Phase 1 Franklin Close interface

The Detailed Component

Planning Application amendments

503-PTA-PH1-00-DR-LA-4301_S4-PL4

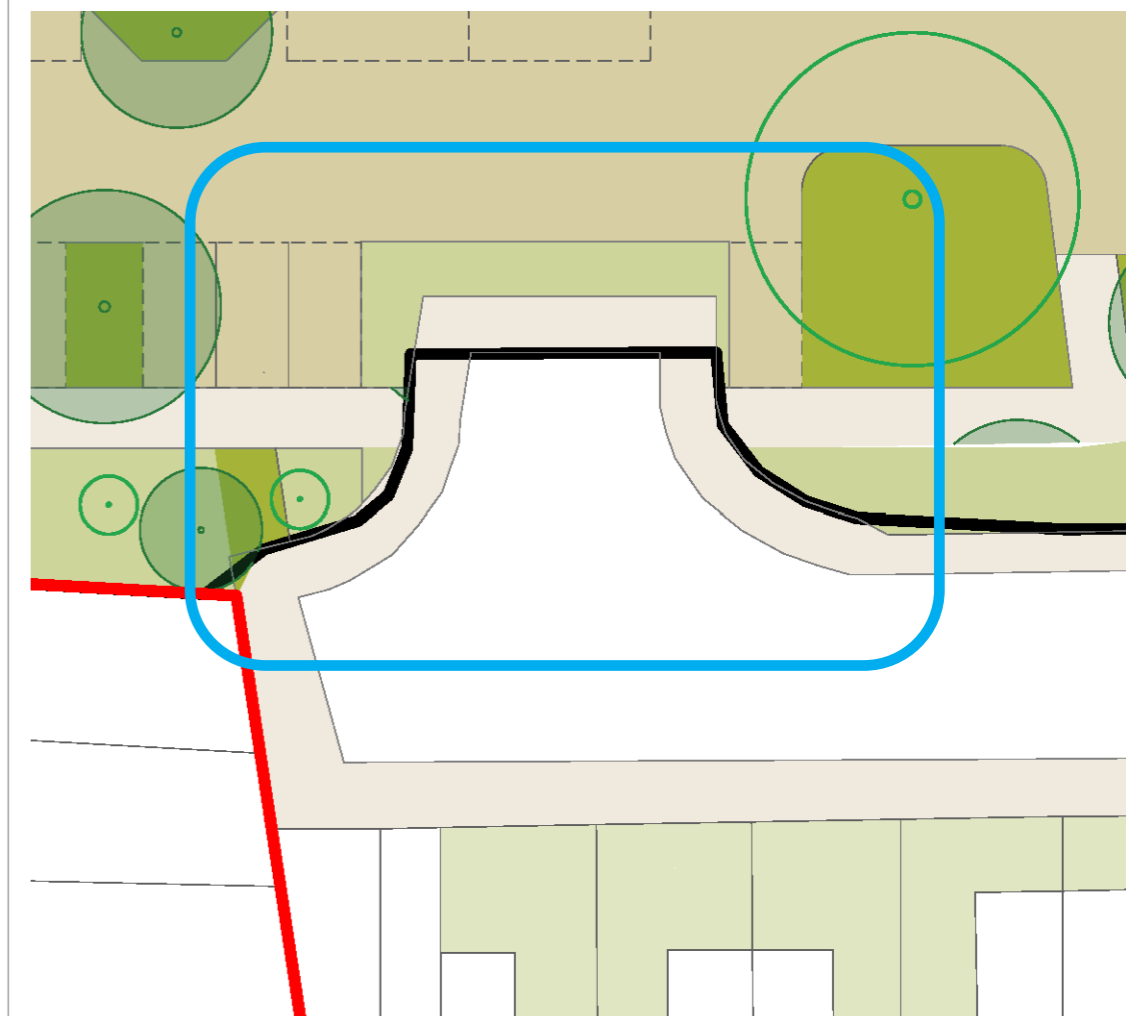
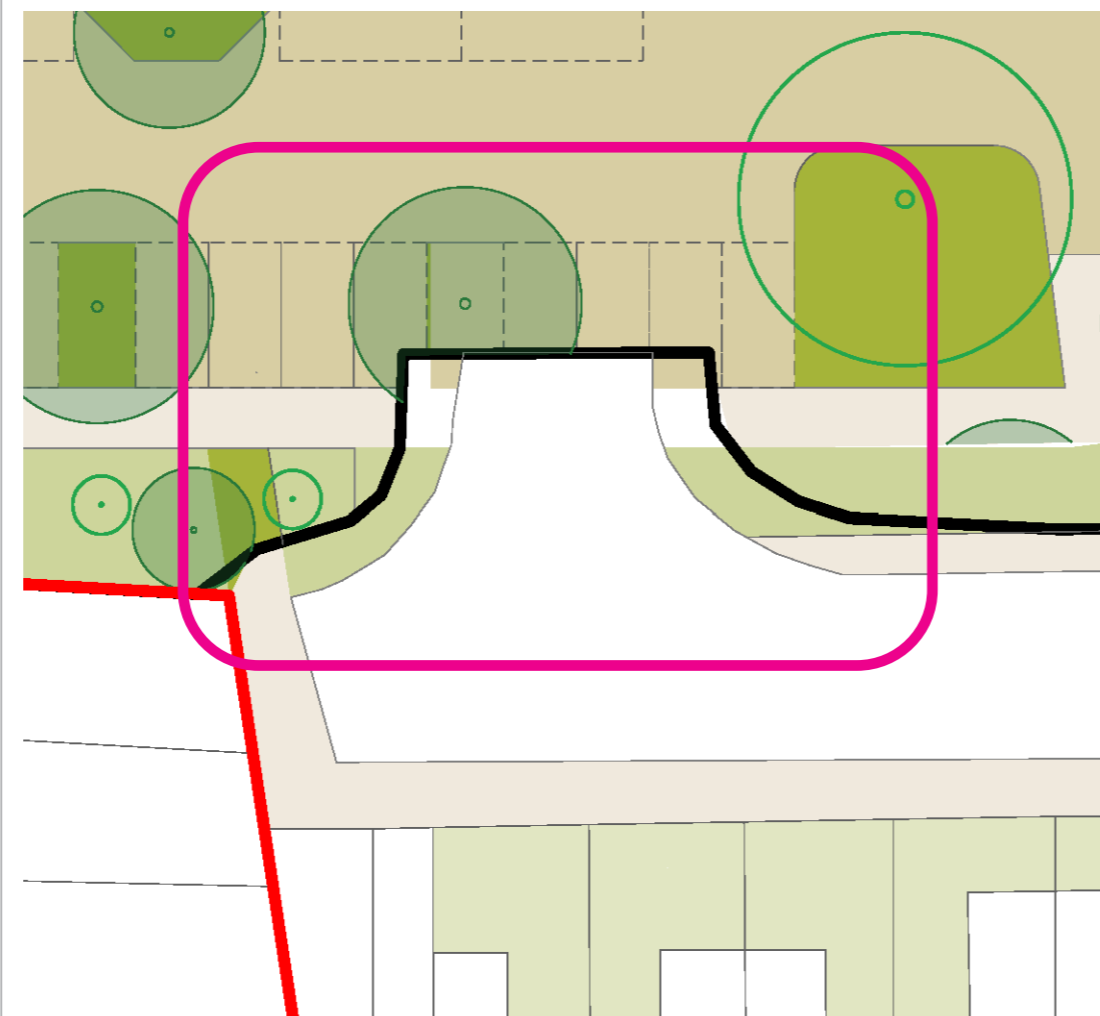
In response to RBK Highways comments, amendments are proposed to the Phase 1 landscaping interface with the retained Franklin Close. In the long term, Franklin Close will be removed as part of works associated with Plot F of the Masterplan.

Temporary soft landscaping, a grass verge, is proposed to the north of the turning head within Franklin Close, allowing for the full retention of the existing pavement.

The tree proposed to be planted in this location will be held back until later phase works.

503-PTA-CZ-ZZ-DR-A-1321_S4-PL2

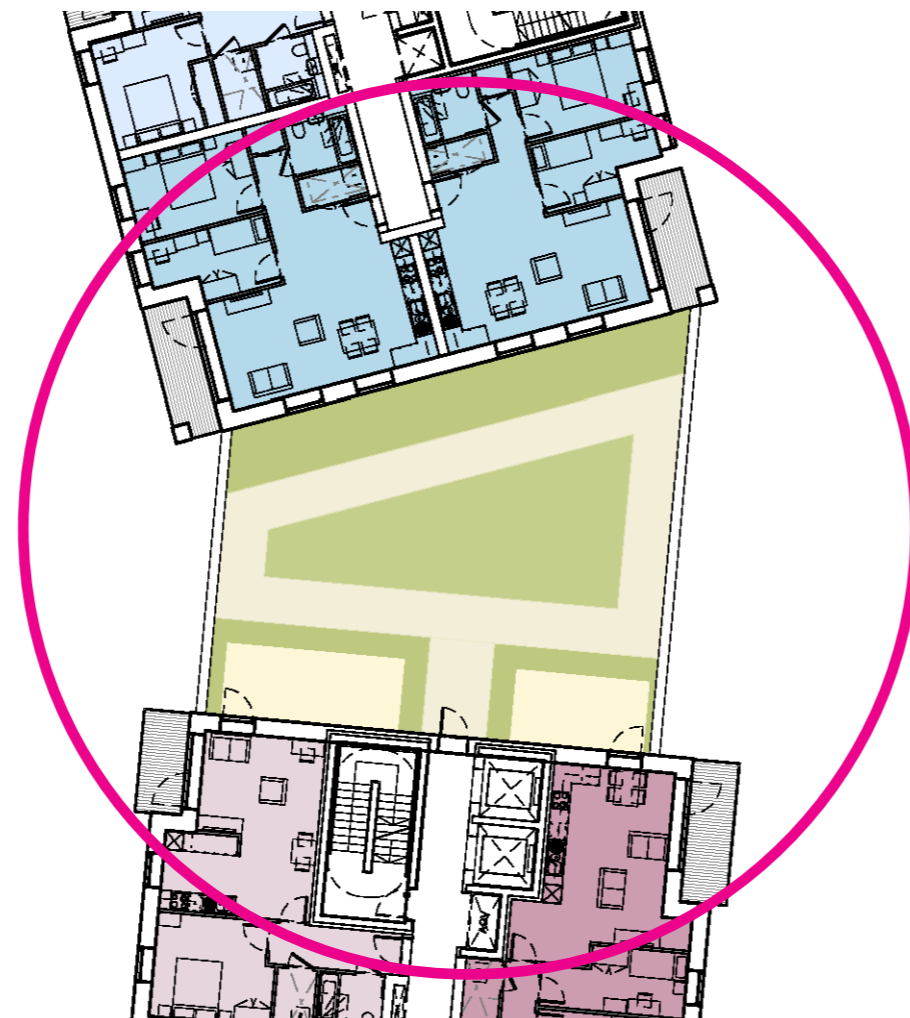
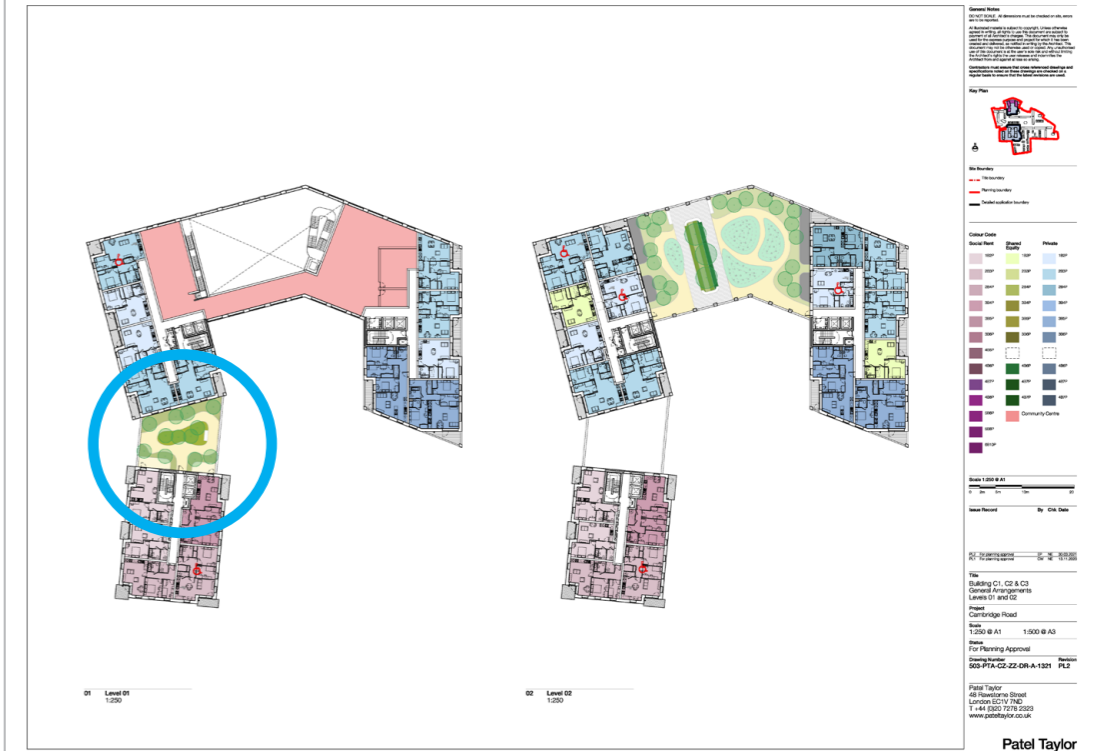
In response to queries from RBK Urban Design, more detail has been provided for the design of landscaping to the Level 01 roof terrace serving Building C3, located above the entrance building which connects C3 with C1.

Design of this terrace now shows an equivalent level of detail to the podium gardens at Level 02 between Buildings C1 and C2, and to the podium gardens at Level 01 within Plot E.

503-PTA-EZ-ZZ-DR-A-1920_S4-PL3

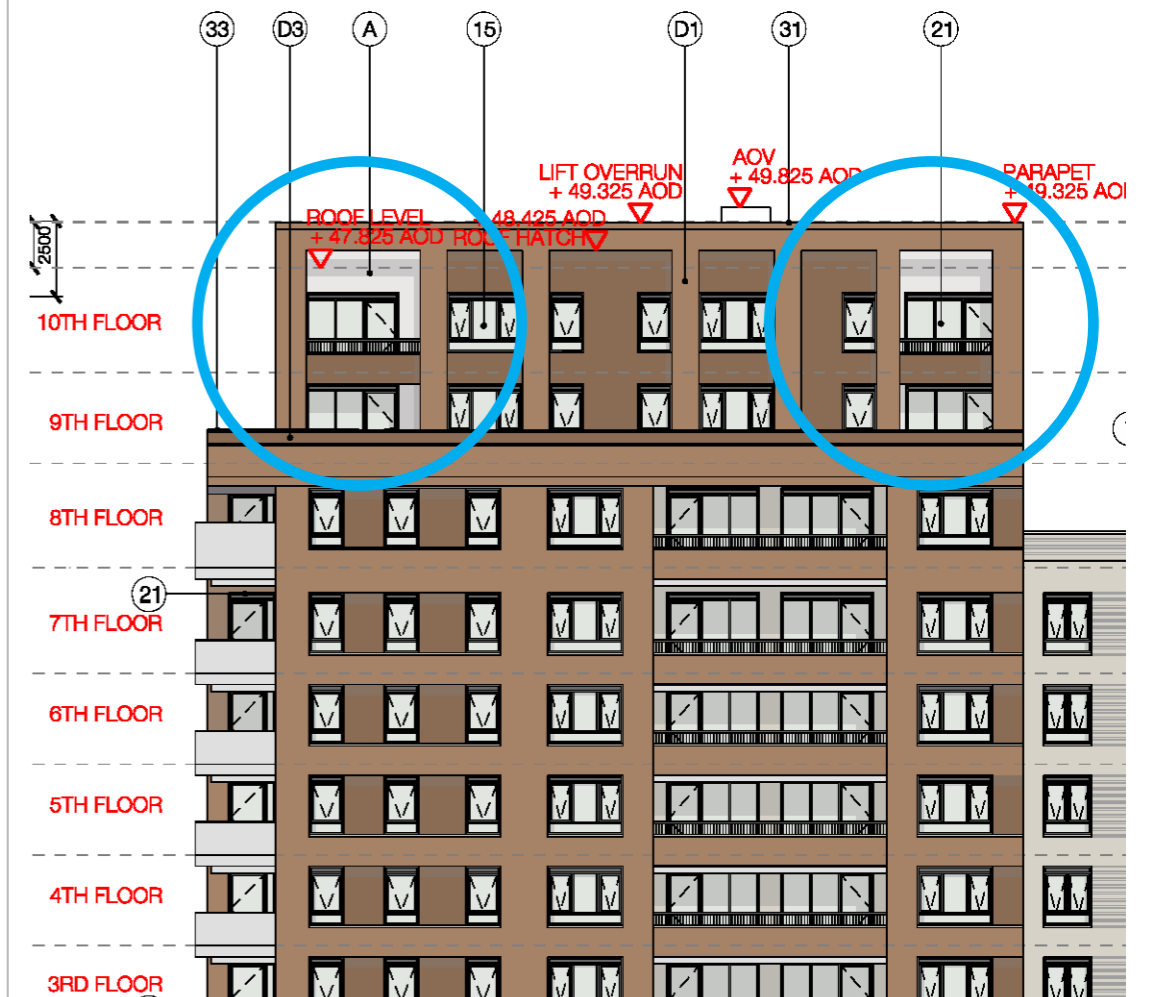
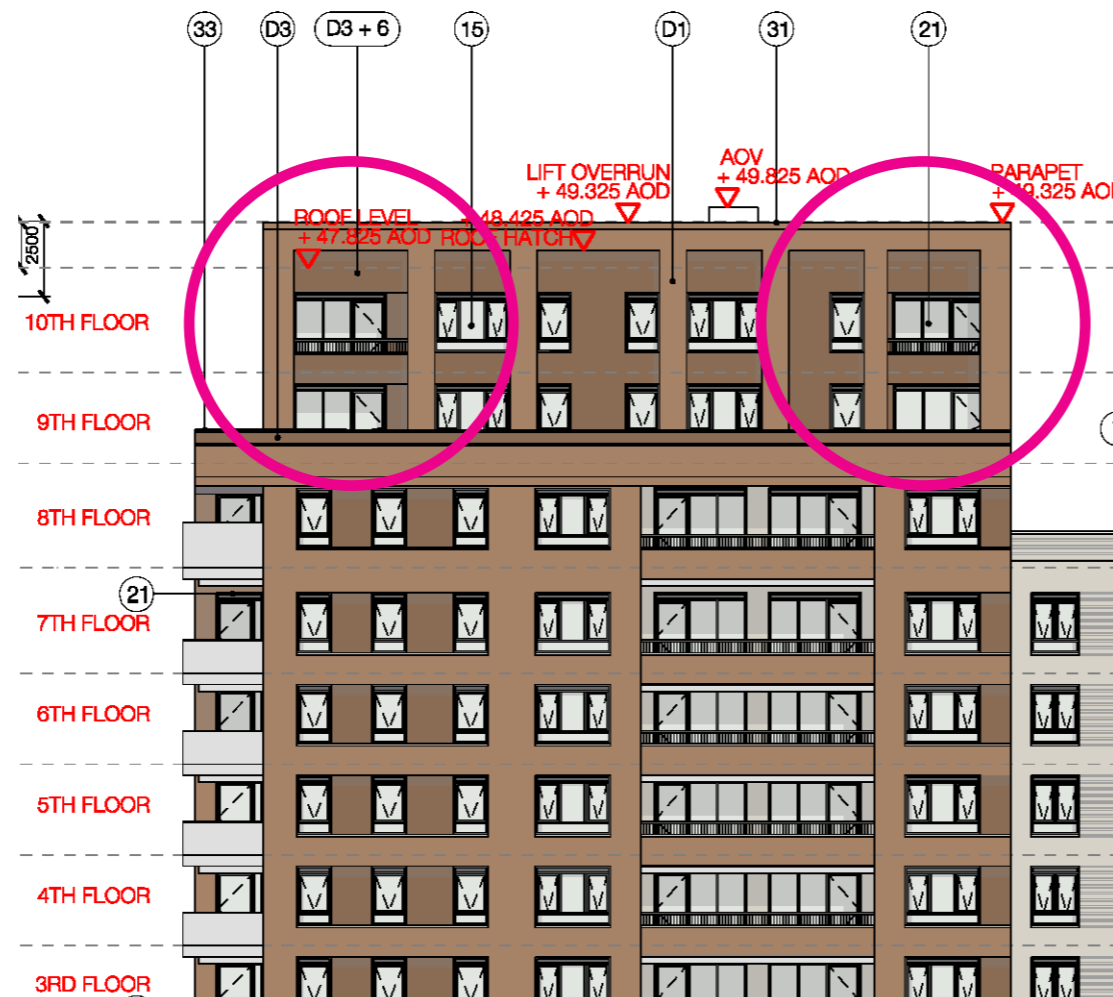
In response to RBK Urban Design Officer comments, the corner balconies on the upper two storeys of Buildings E2/ E3 have been amended to create a lighter expression on the corners of the building.

The upper roof level has been removed to create a brick 'pergola' frame which maintains the form of the building. The areas of external wall within the recesses have been changed from red to white brick to amplify this effect, and to echo a similar detail proposed for Building C1.

The change is demonstrated using the General Arrangement Elevation drawing 503-PTA-EZ-ZZ-DR-A-1920, and can also be seen on the following elevation drawings:

503-PTA-EZ-ZZ-DR-A-1361_S4-PL2

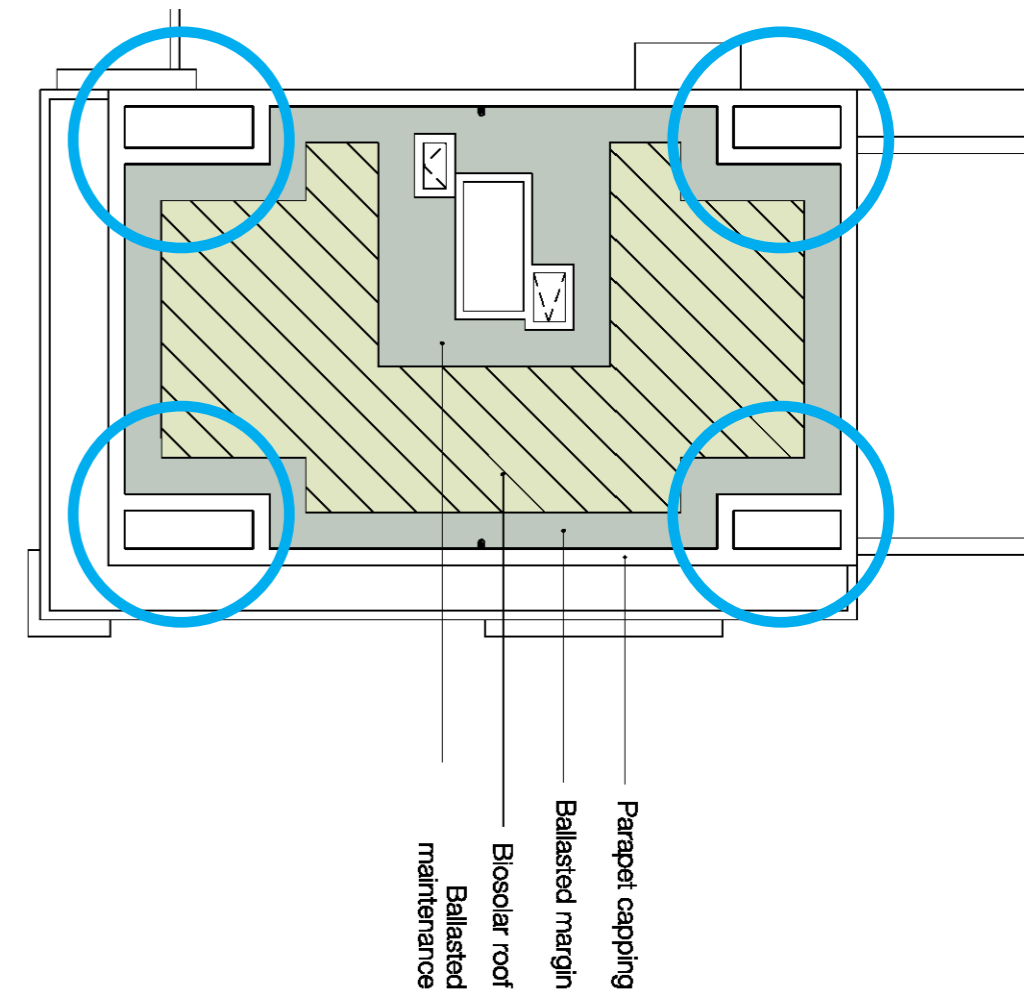
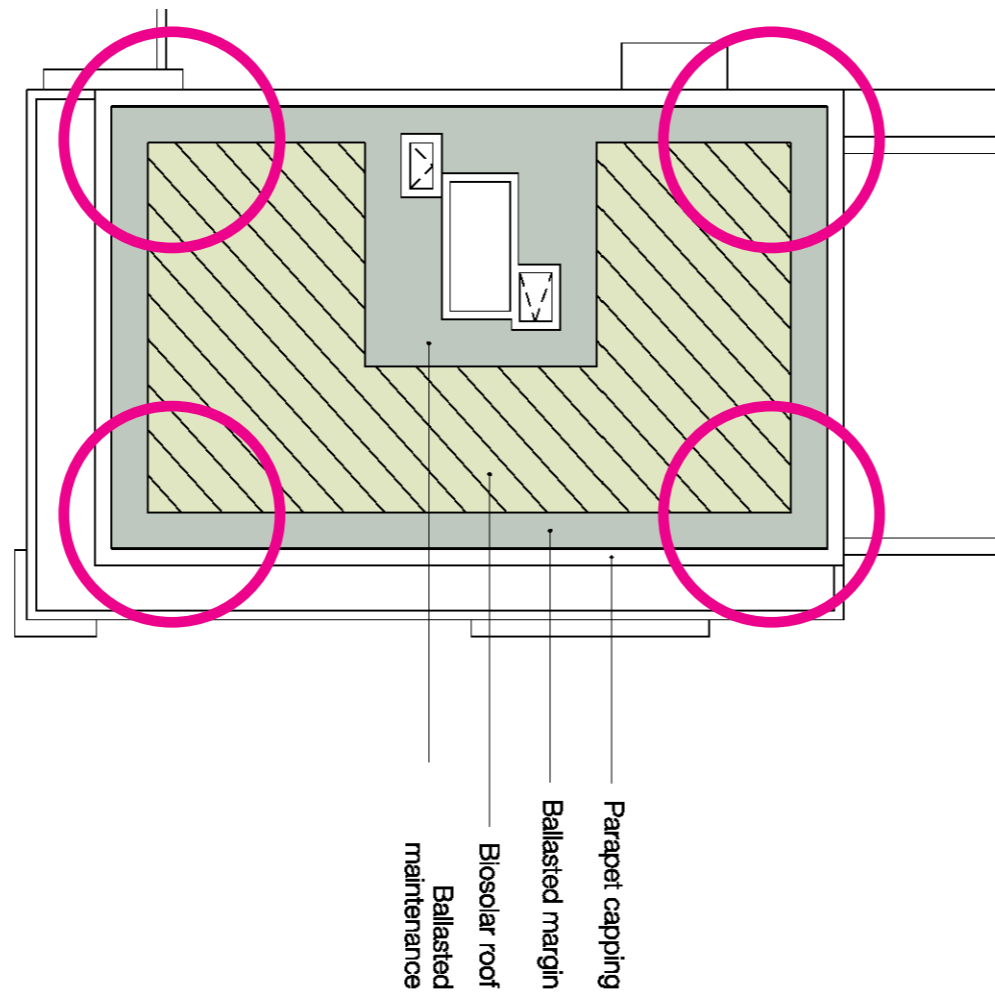
The same upper-level change is evidenced here on the consolidated roof plan of Plot E.

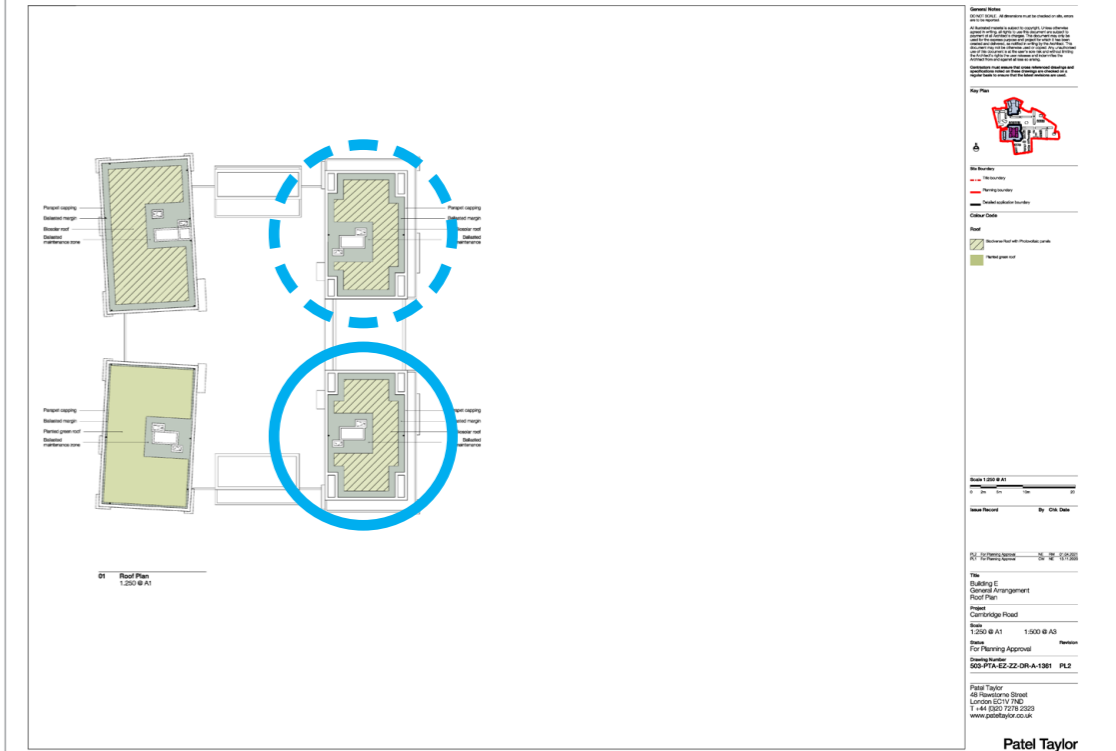
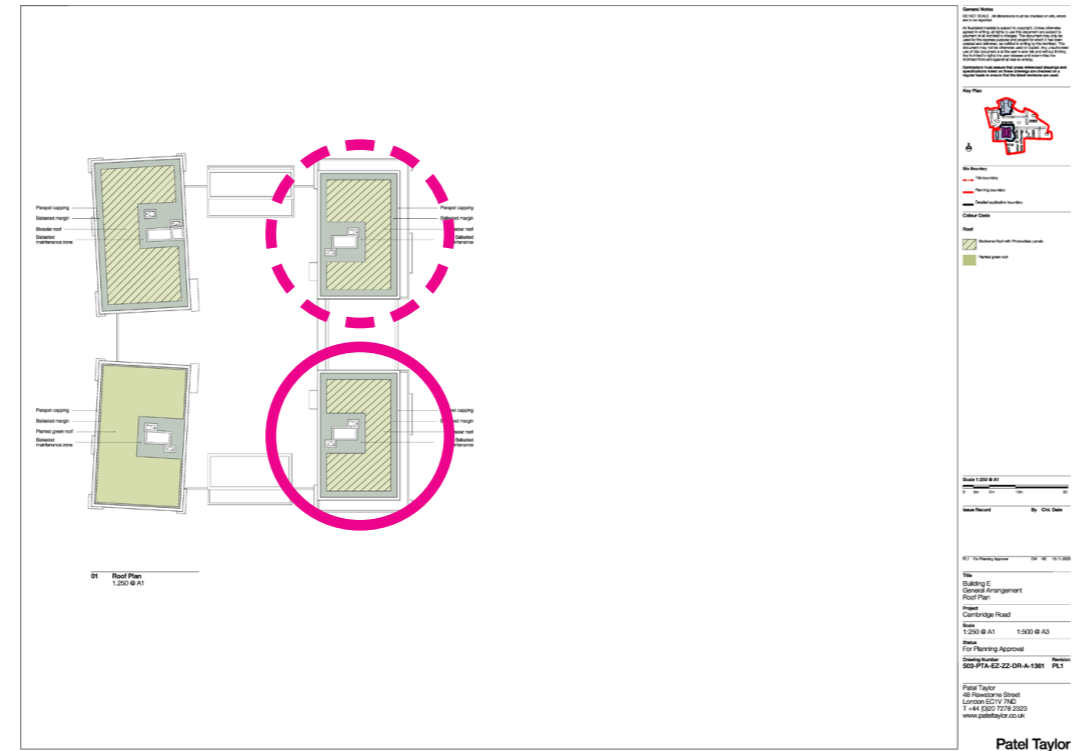
The same upper-level change is evidenced here on the illustrative views of Plot E extracted from the Townscape Assessment.
